MORGANTOWN PLANNING COMMISSION

STAFF REPORT

CASE NO: S15-11-III / Feoh Realty, LLC / Donahue Drive

PLANNING AND ZONING CODE CONFORMITY REPORT FOR PLANS DATED 06 NOV 2015

SHEET 3 PROPOSED SITE CONDITIONS

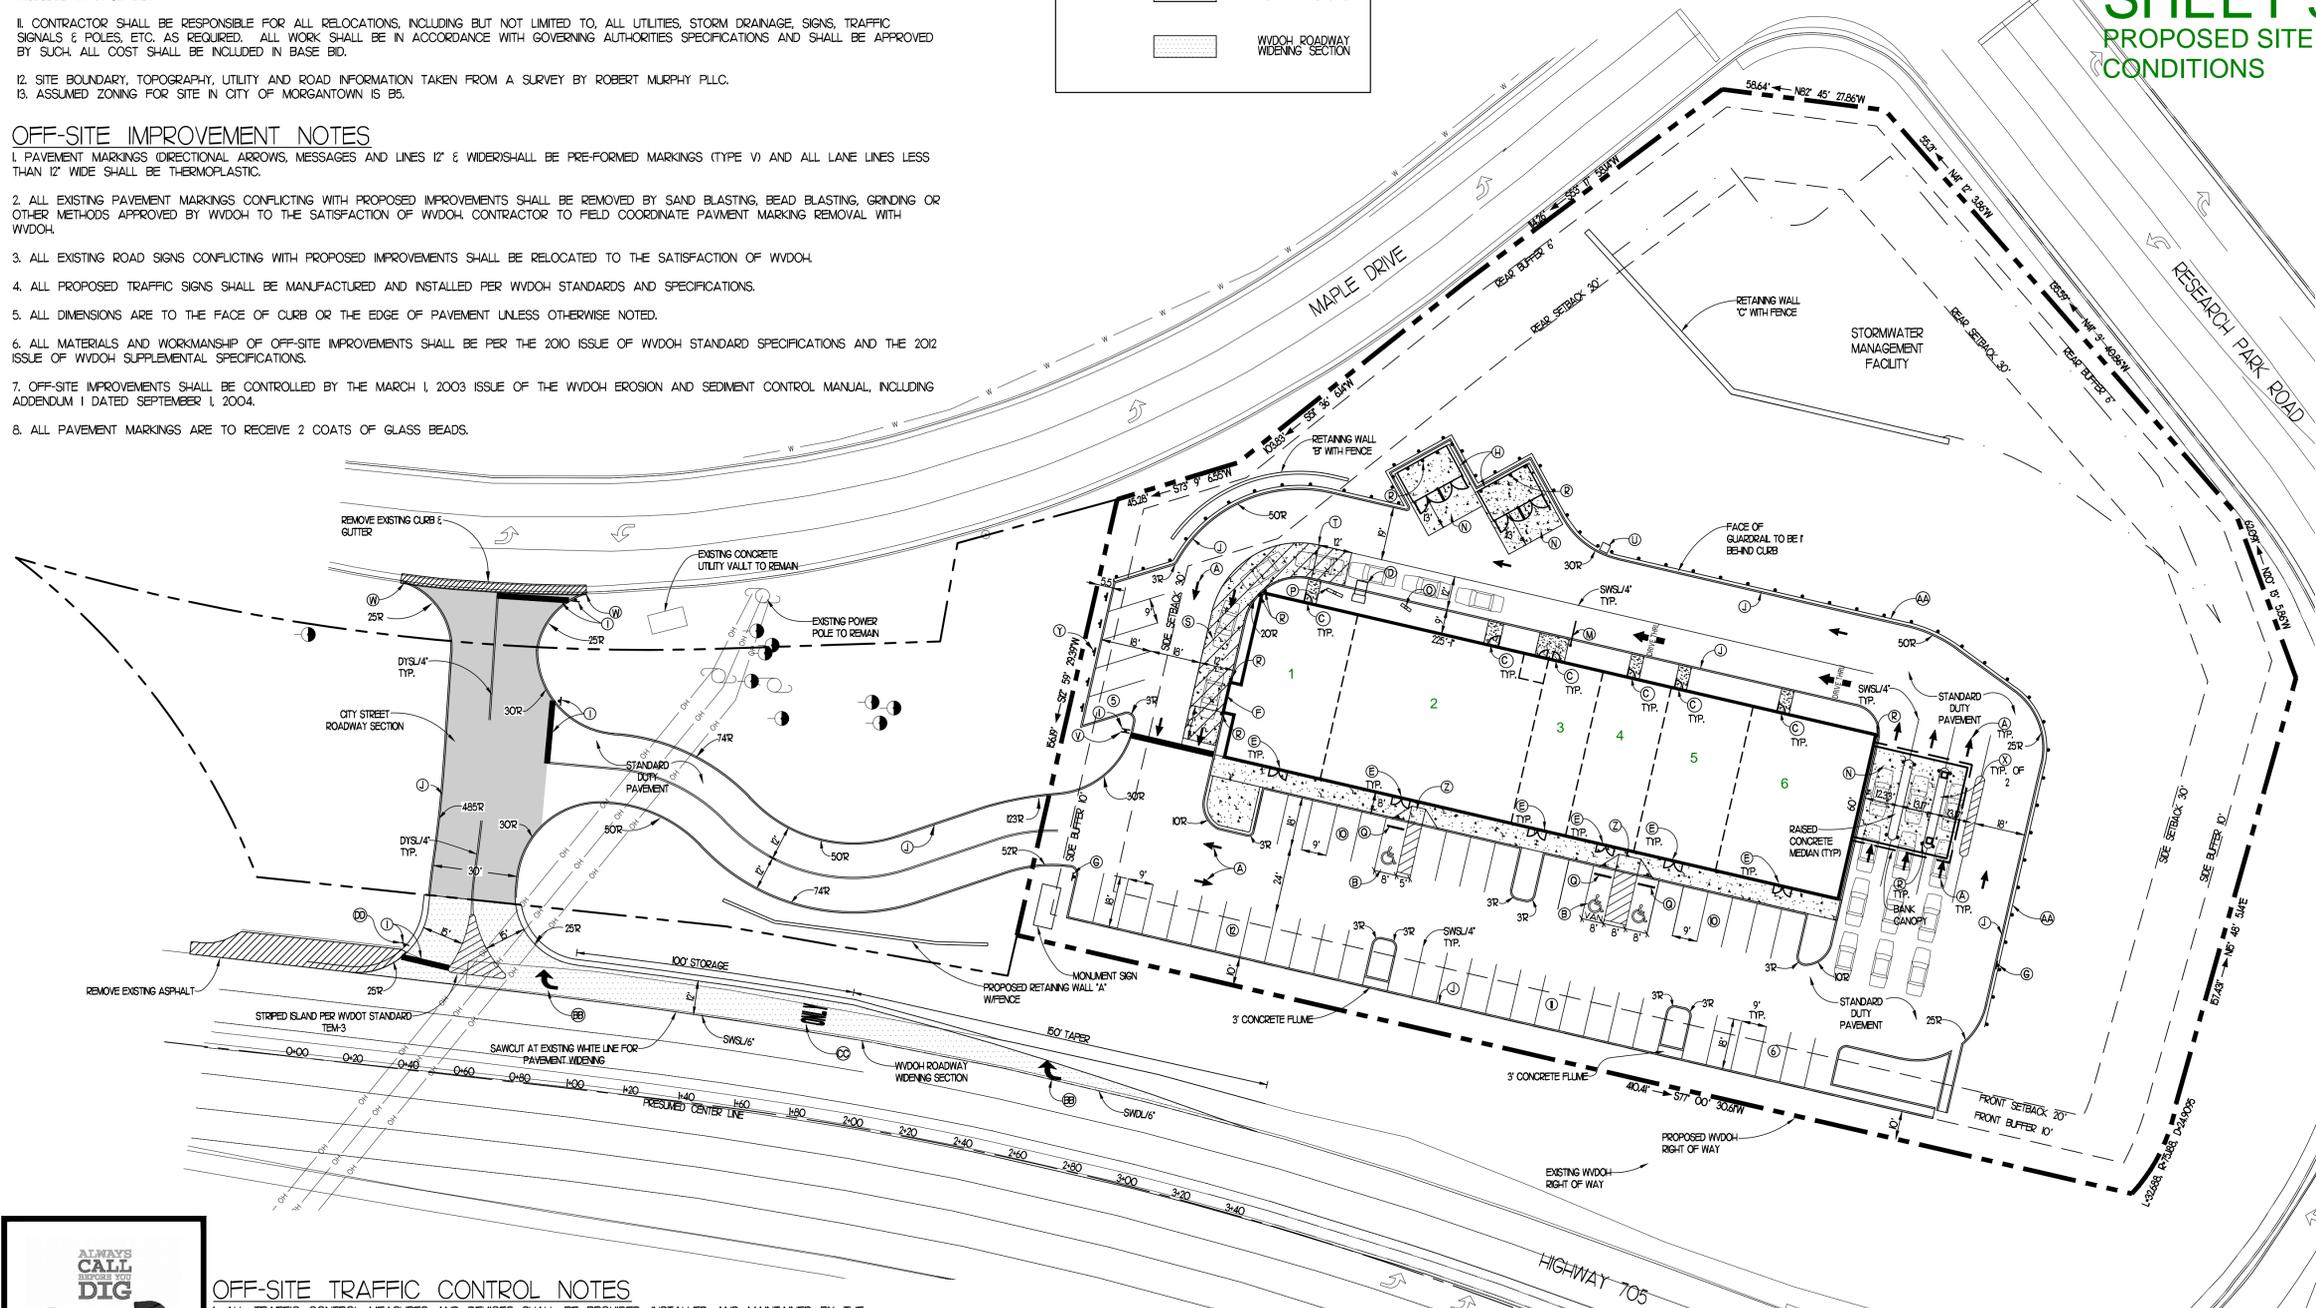
Note – 1A “Pedestrian Circulation Plan” was not submitted with plans reviewed herein as required by Article 1365.04(N). Addendum A of this report provides suggested design modifications, which will be submitted to the Planning Commission as a recommended condition of Site Plan approval; provided, the City Engineer is in agreement with pedestrian circulation measures.

Note – 2The five (5) angled parking spaces at the west side of the site remain a concern given the limited line-of-sight for approaching vehicles via the 19-foot wide bypass drive aisle and the potential conflict with back-out movements from said spaces toward vehicles in the drive-through aisle. Said spaces should be restricted to “Employee Parking Only” and signed accordingly to reduce parking space turnover frequency. The developer has agreed to establish this parking restriction, which is identified on Sheet 3 Drawing 9 as Note “Y.” To ensure this parking restriction is implemented, a related condition will be submitted to the Planning Commission as a recommended condition of Site Plan approval.

2. That requisite variance approvals must be granted by the Board of Zoning Appeals and related conditions observed.
3. That, to the satisfaction of the City Engineer, a Pedestrian Circulation Plan must be submitted with the Building Permit Application and include minor site design modifications illustrated in, or similar to, Addendum A of Staff's Planning and Zoning Code Conformity Report dated 25 NOV 2015 thereby furthering public safety and welfare.

4. That, to the satisfaction of the Planning Division, the five (5) angled parking spaces at the west side of the development site be restricted to "Employee Parking Only" and signed accordingly (vertical signage and/or pavement markings) to reduce turnover frequency of said parking spaces thereby furthering public safety and welfare.

SHEET 4
PRELIM LANDSCAPE
PRELIM SITE LIGHTING

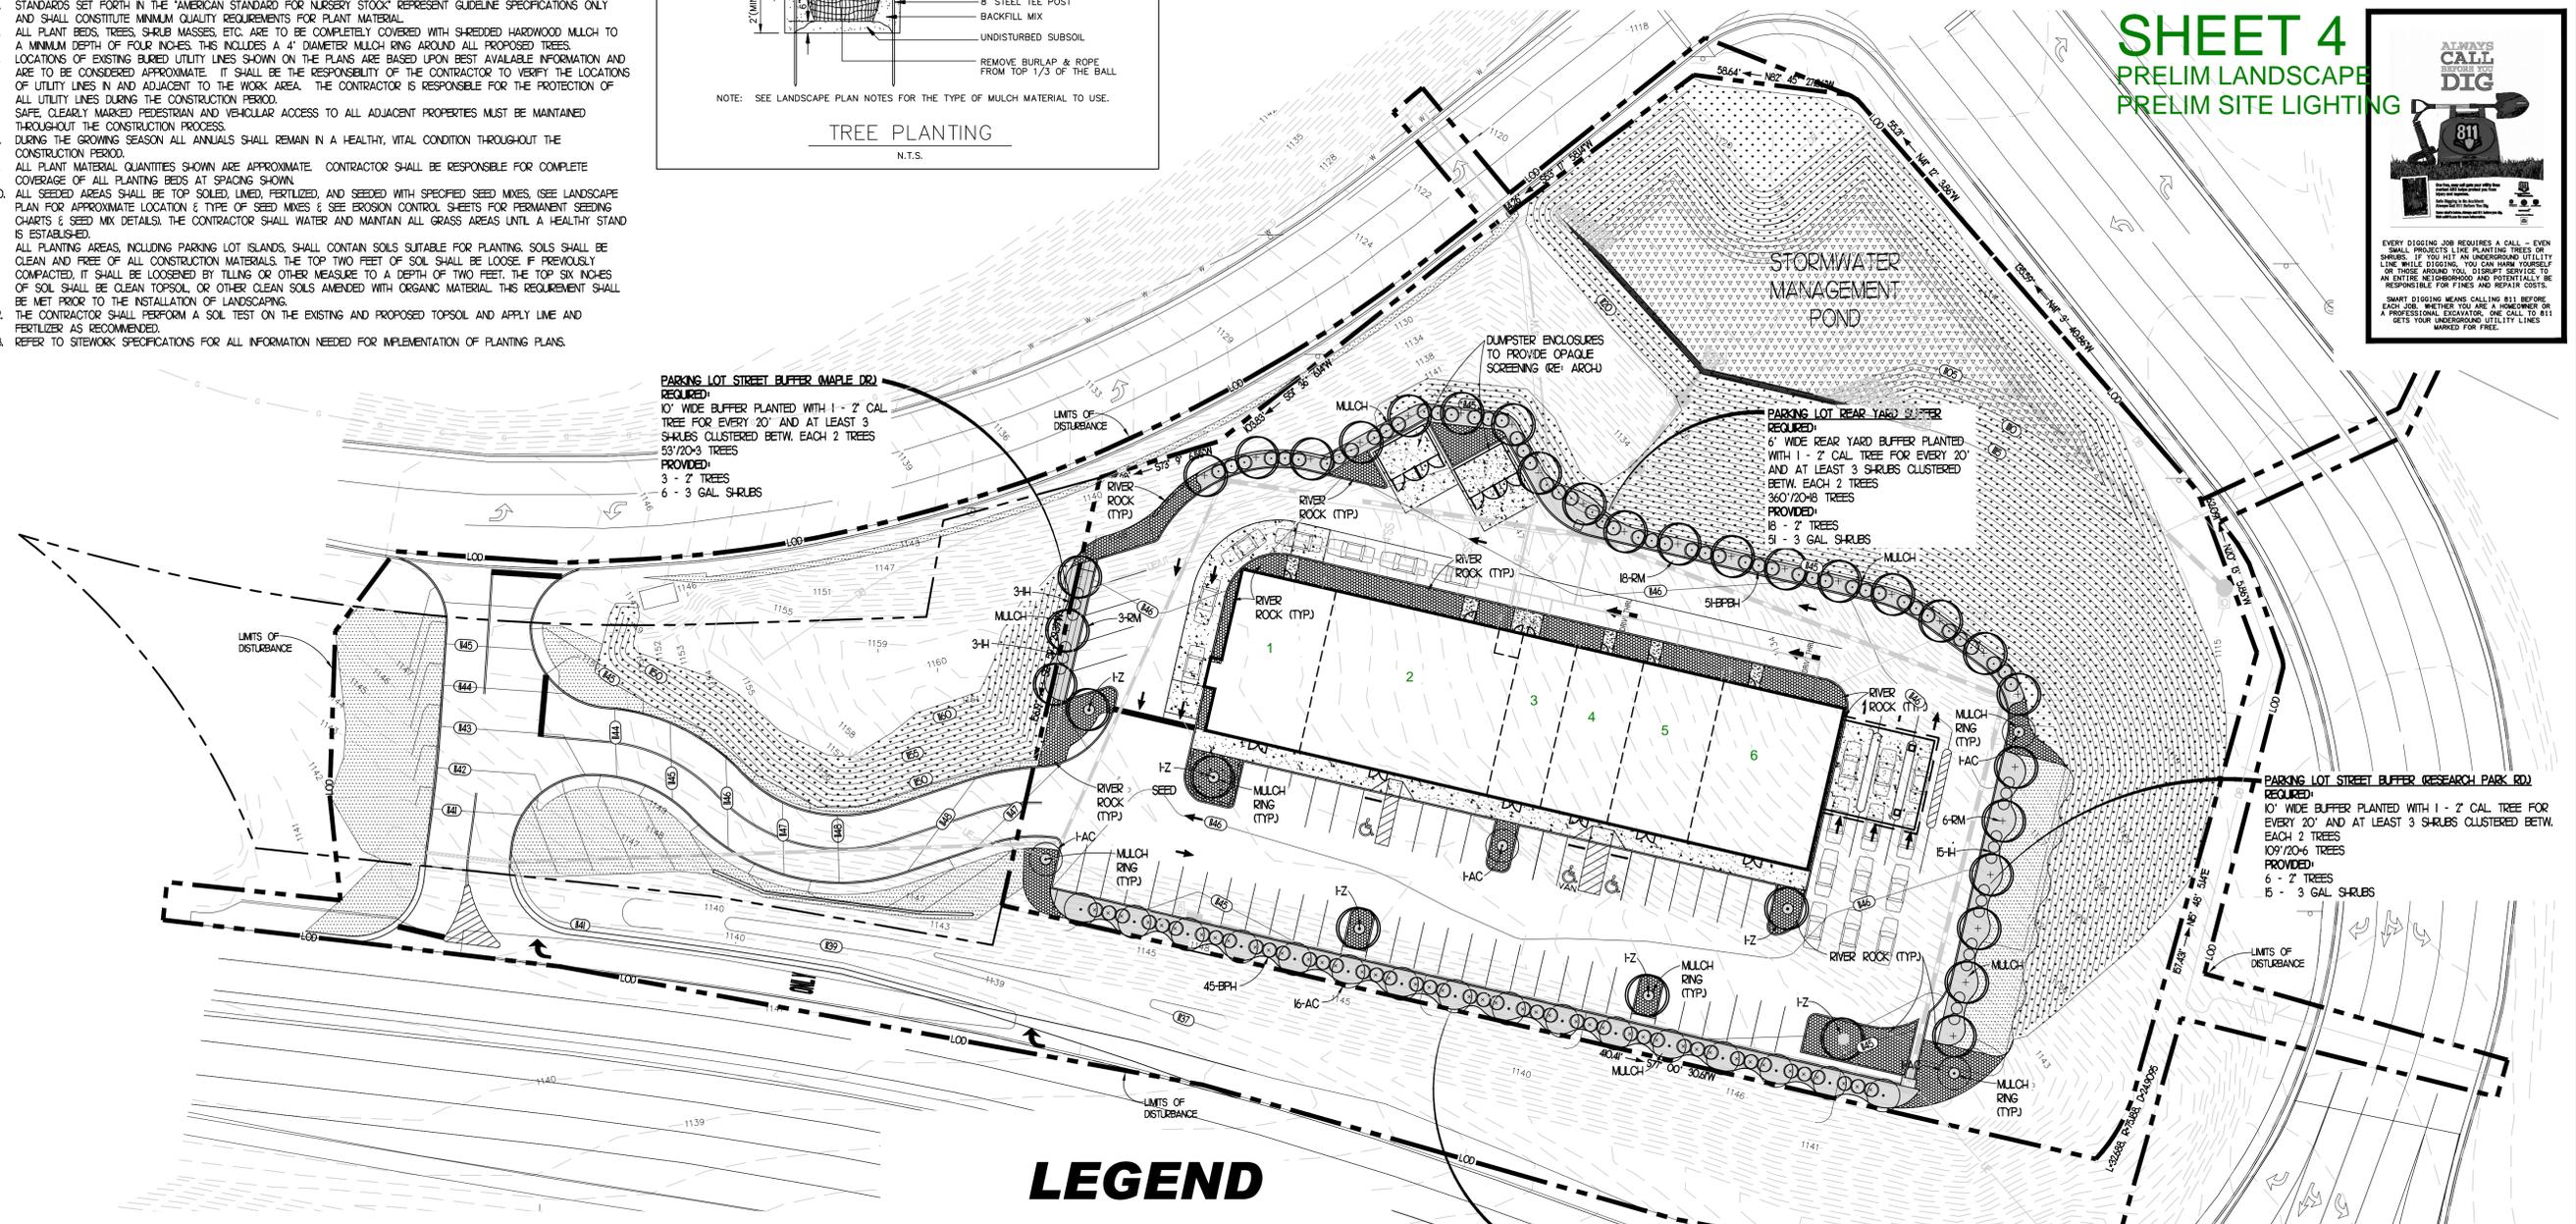
TBD	<i>The Preliminary Landscaping Plan on Sheet 4 Drawing 20 appears to provide requisite buffer/screening planting areas for development with parking located between the building and the street [1367.08(C)] and for interior landscaping [1367.08(D)]. Sufficient screening/enclosures appear to be proposed around trash dumpsters [1367.06(E)]. The final Landscape Plan, including specific plant materials, spacing, etc. will be reviewed during building permit application.</i>
-----	-----------------------------------------------------------------------------------------------------------------------------------------------------------------------------------------------------------------------------------------------------------------------------------------------------------------------------------------------------------------------------------------------------------------------------------------------------------------------------------------
